REMARKS

Claims 1-20 remain pending in the application with the present amendments. In the Office Action, the drawings were objected to under 37 CFR 1.83(a) as not showing every feature of the invention specified in the claims. The drawings are amended herein to show the features, i.e., cooperating openings in the computing device, engageable and engaged by attachments, e.g., latches, of the adapter. An annotated sheet showing the specific changes to the drawings in red (addition of FIGS. 1B and 1C) is attached hereto for the Examiner's perusal.

FIG. 1B

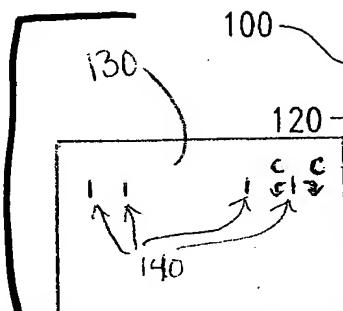
Corresponding amendments are made to the specification with the present changes to the drawings. With reference to paragraphs [0027] and [0028] of the originally filed specification, and original claims 7 and 15, all of the subject matter in the amended drawings and the specification is disclosed in the application as originally filed. Applicants submit that no new matter is introduced by way of the present amendments.
